BID CLARIFICATION 2 FOR REQUEST FOR PROPOSALS FOR NEXUSPARK FIELDHOUSE DESIGN/BUILD

Columbus, Indiana

Issued: April 8, 2022

E00-03

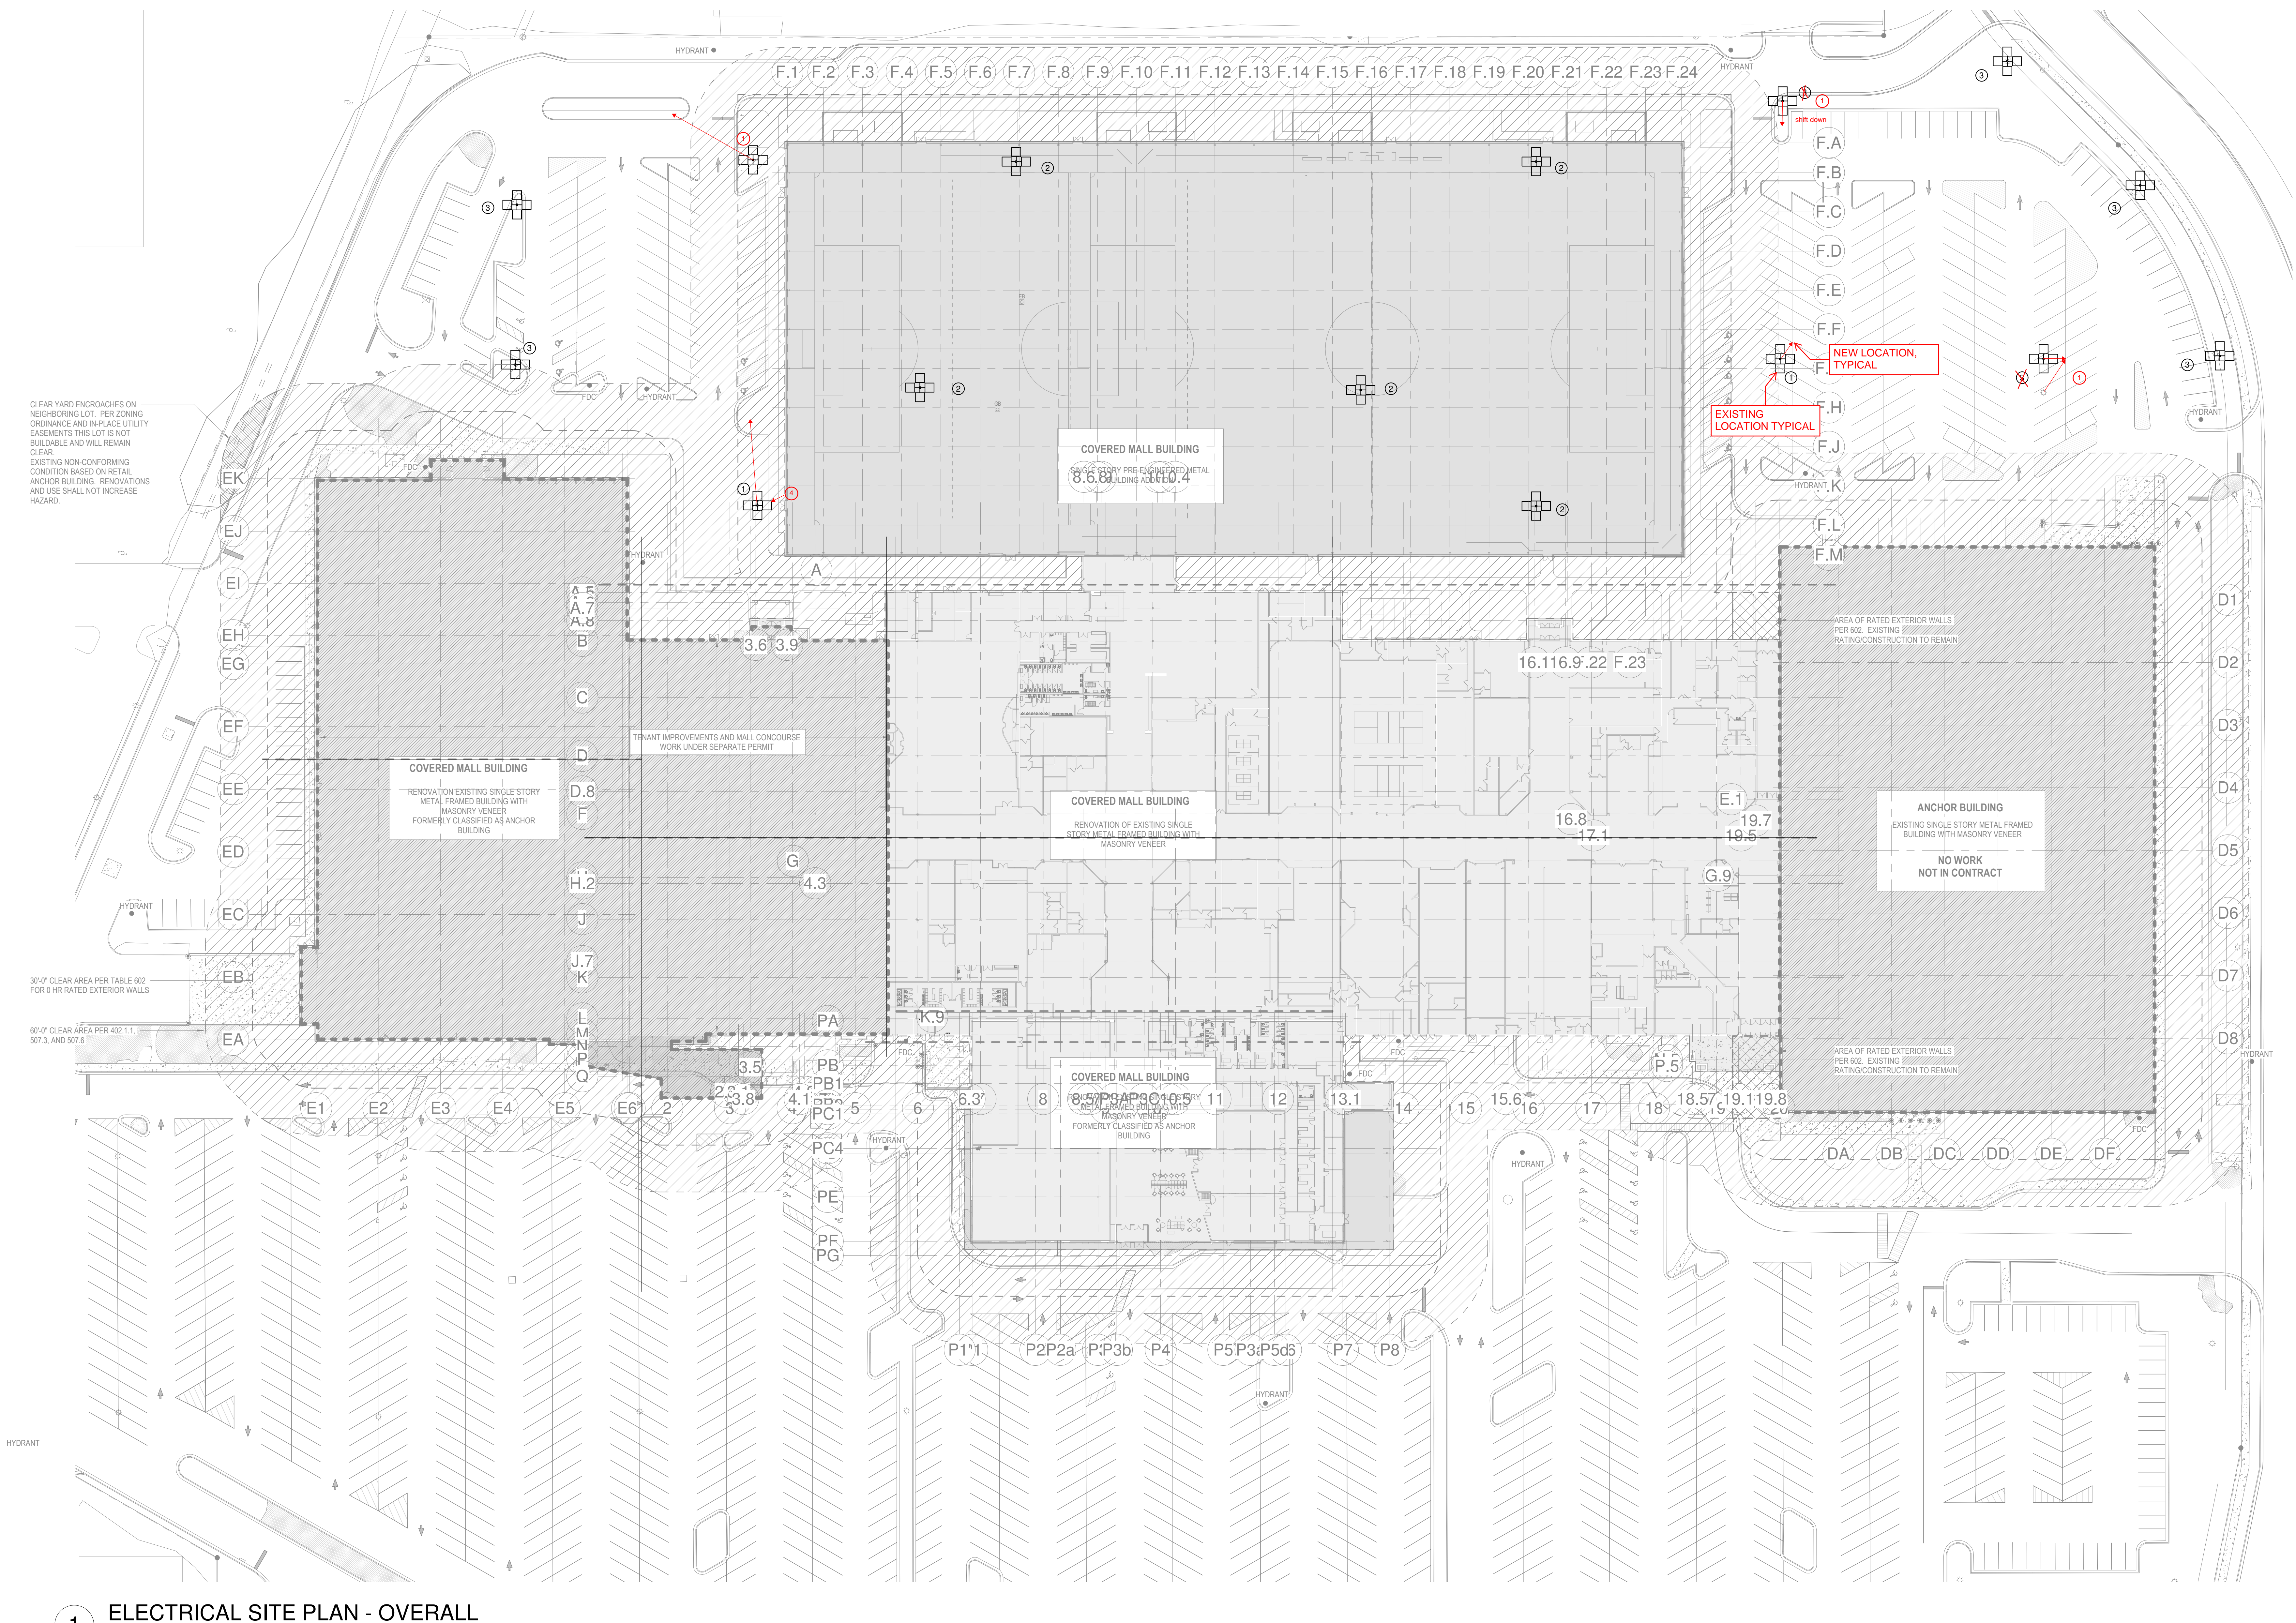
Question F26: E00-03 is vague as to the re-work required to keep existing pole lights that are staying powered up. Should we carry a contingency for this work?

Answer: See attached mark-up. Note One should have read existing fixture to be relocated. Match existing base. One fixture is tagged note 3, should be note 1. Also, see original circuiting of site lighting which shows wiring to be reworked.

T50-11

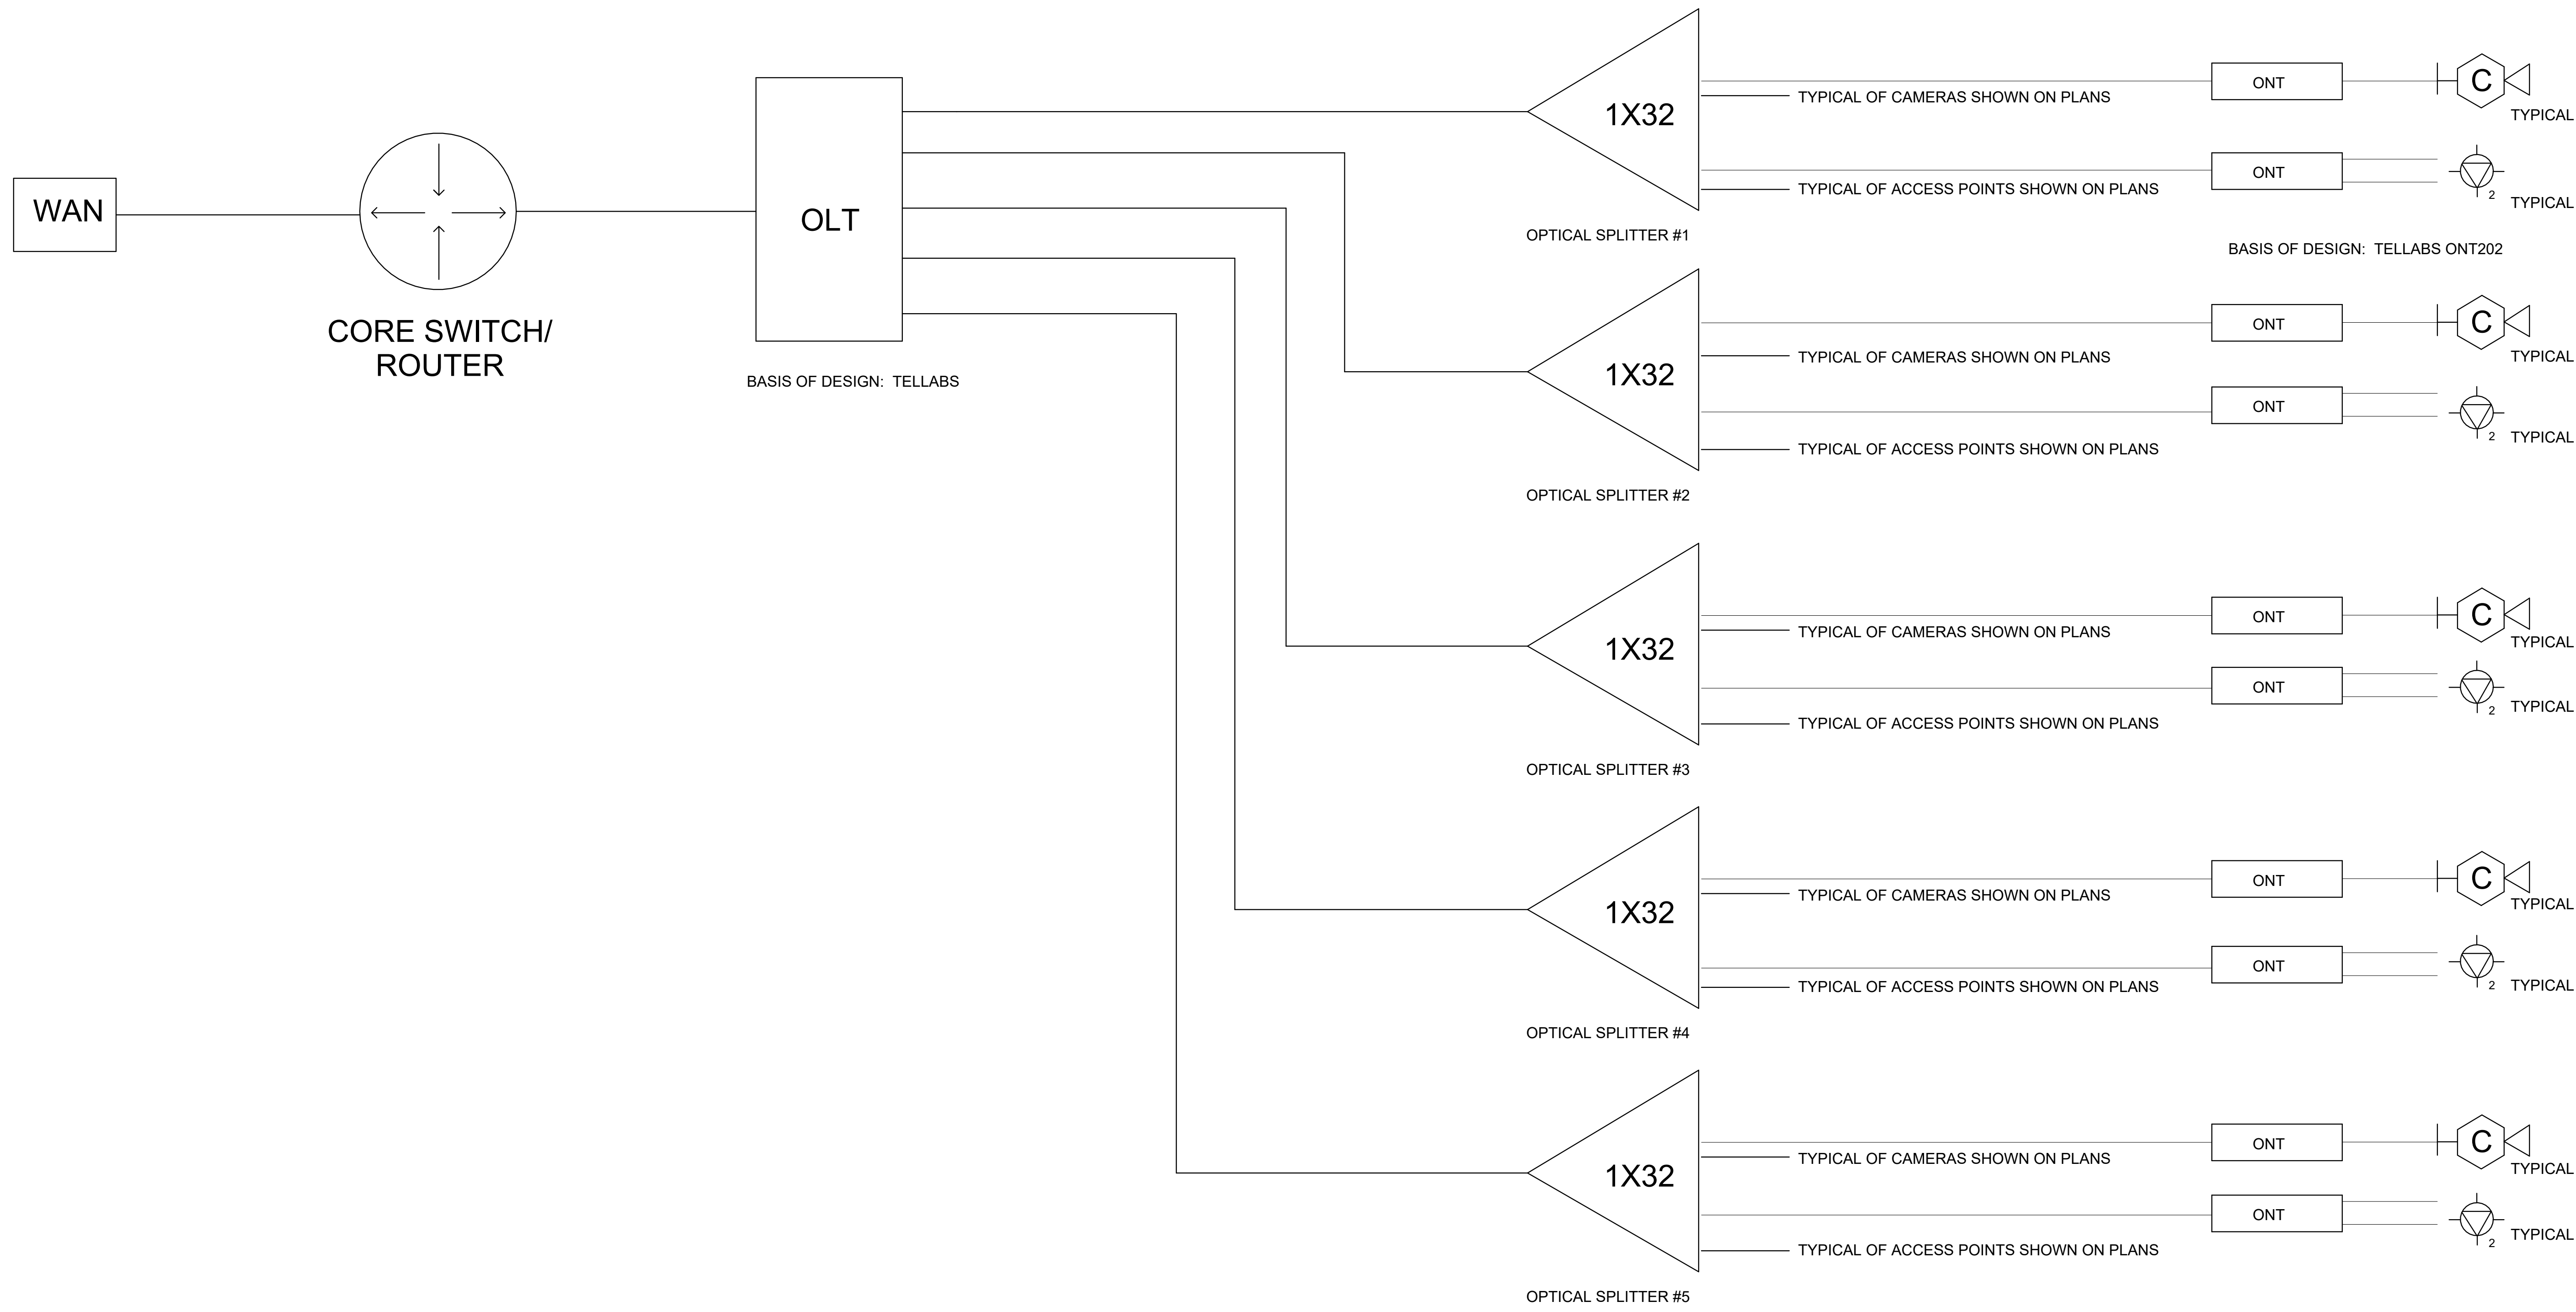
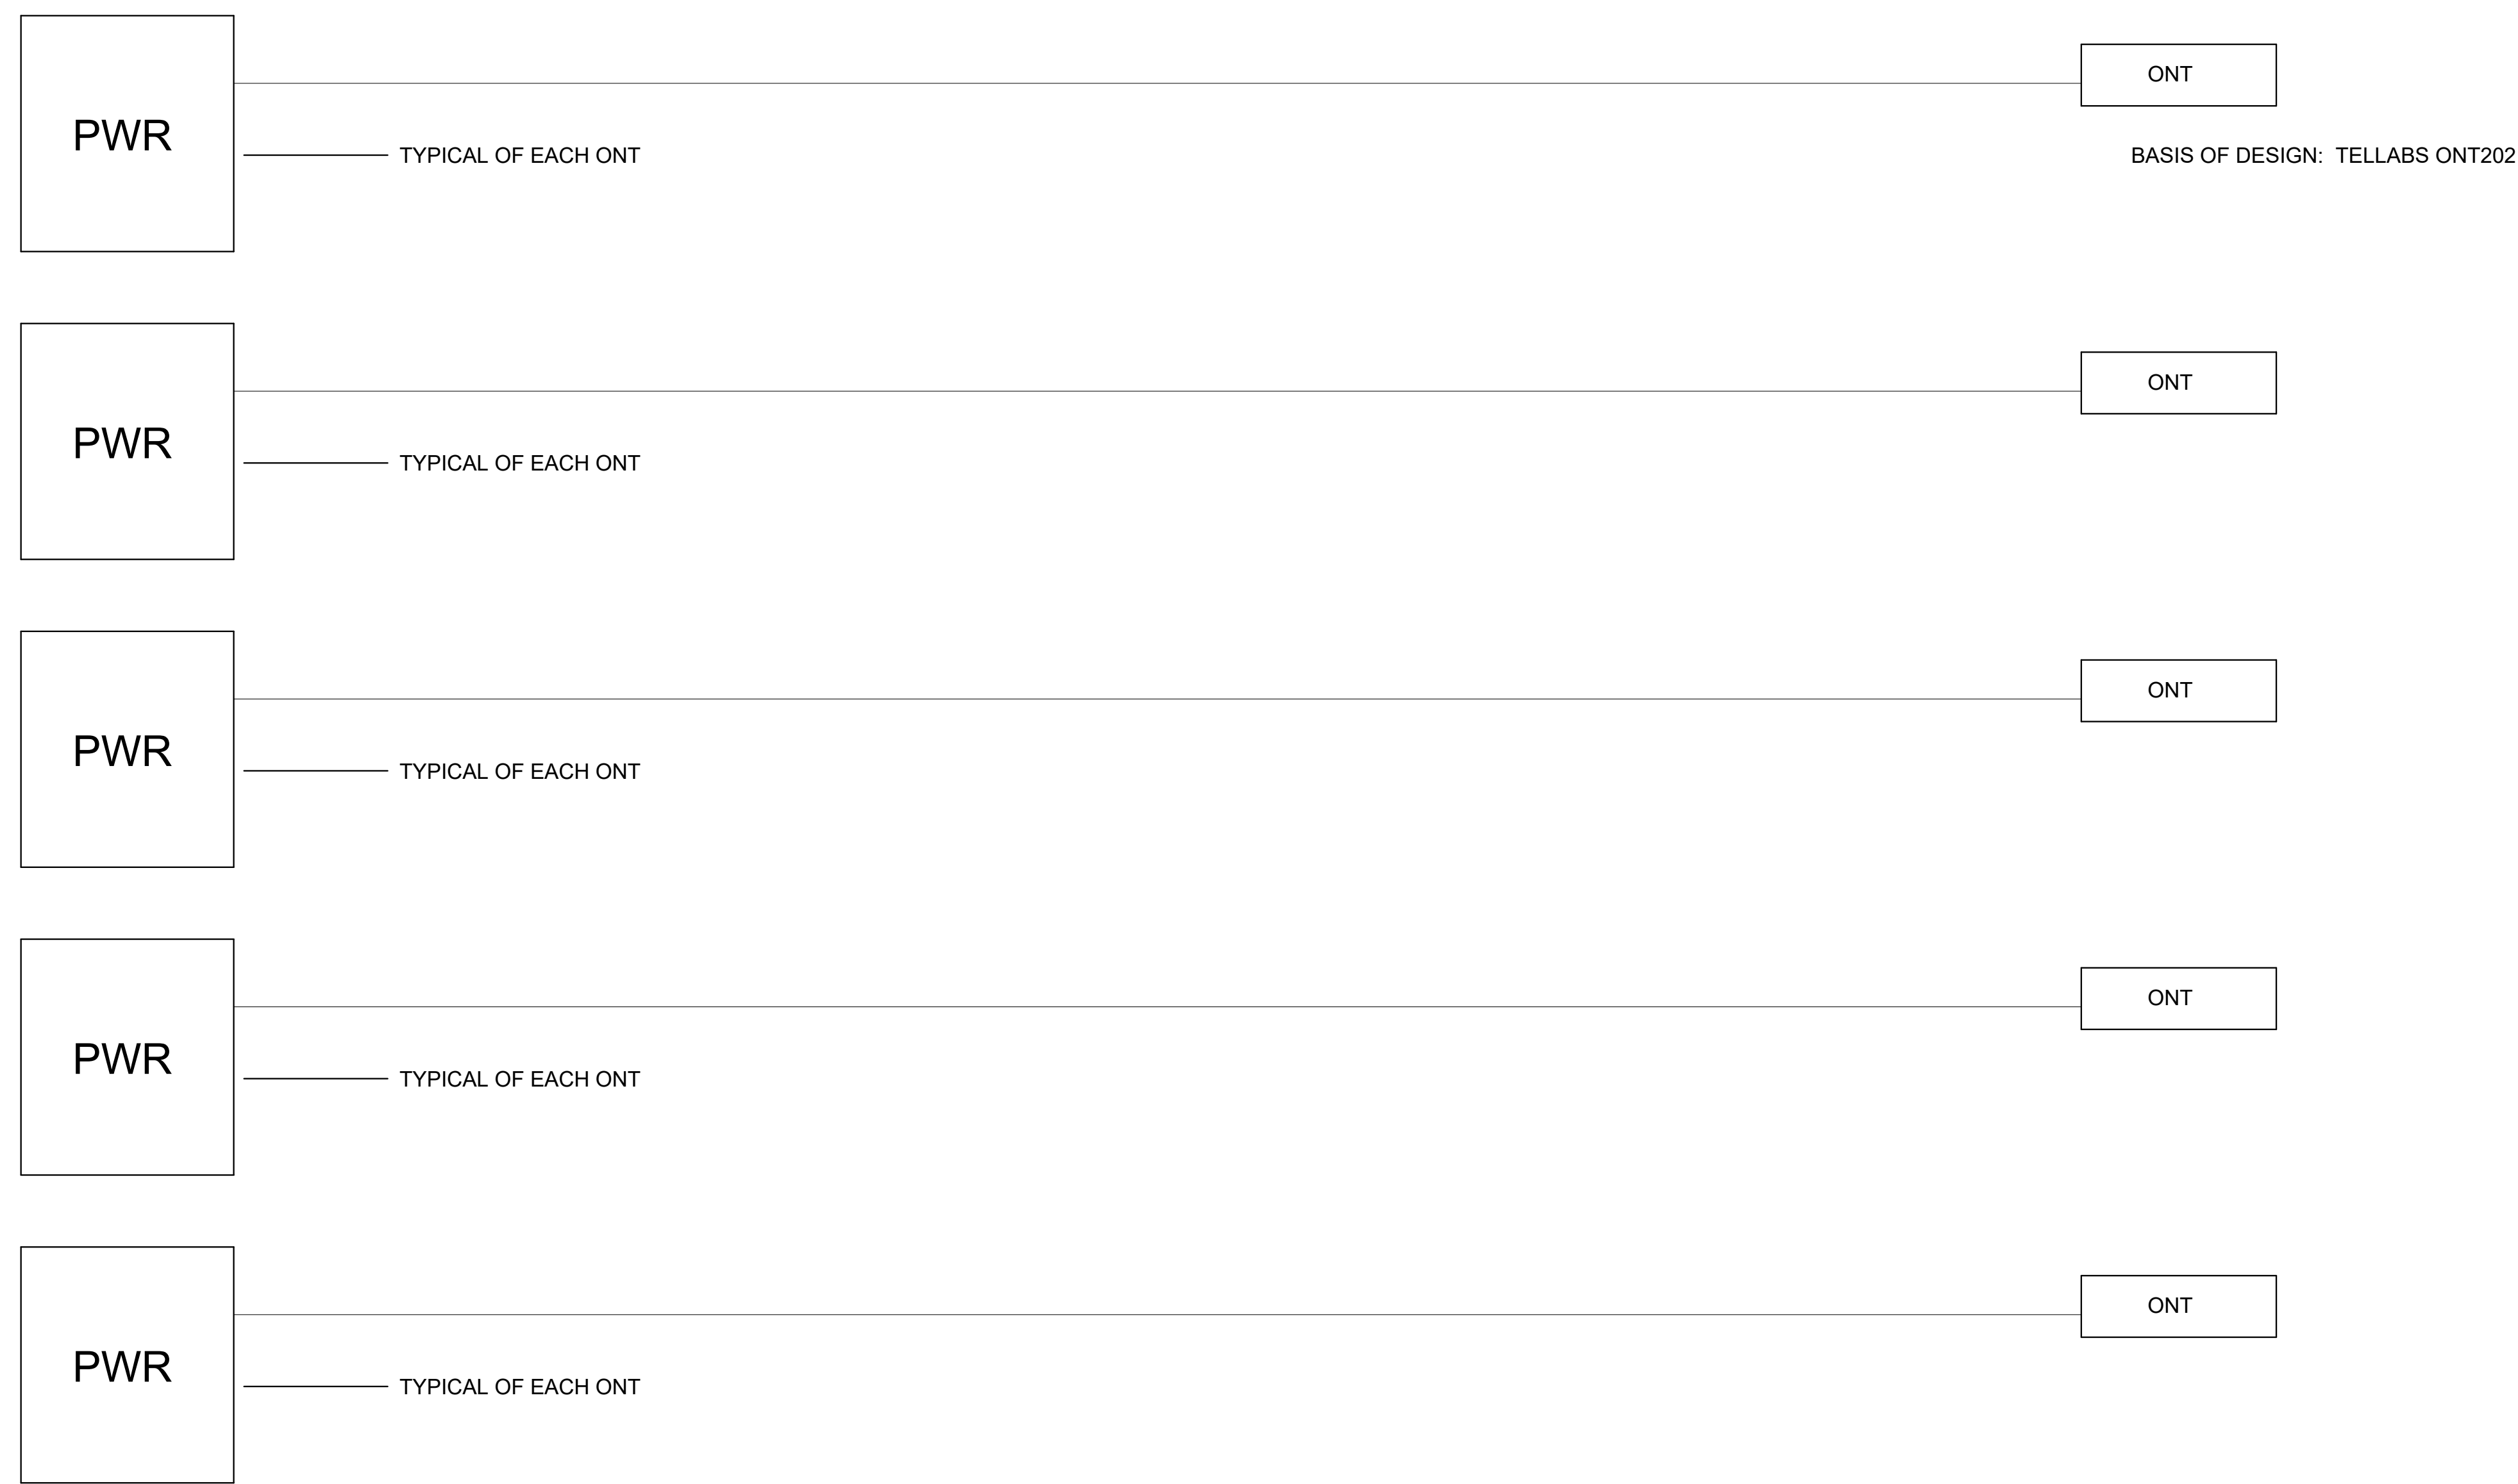
Question F11: It appears that drawings T50-11 and E60-02 are shown in the drawing legends but are not included in any of the drawing sets provided. These drawings are referenced on other sheets, is there a way to obtain these drawings?

Answer: Drawings T50-11 and E60-02 was included in original distribution. Sent separately for reference.
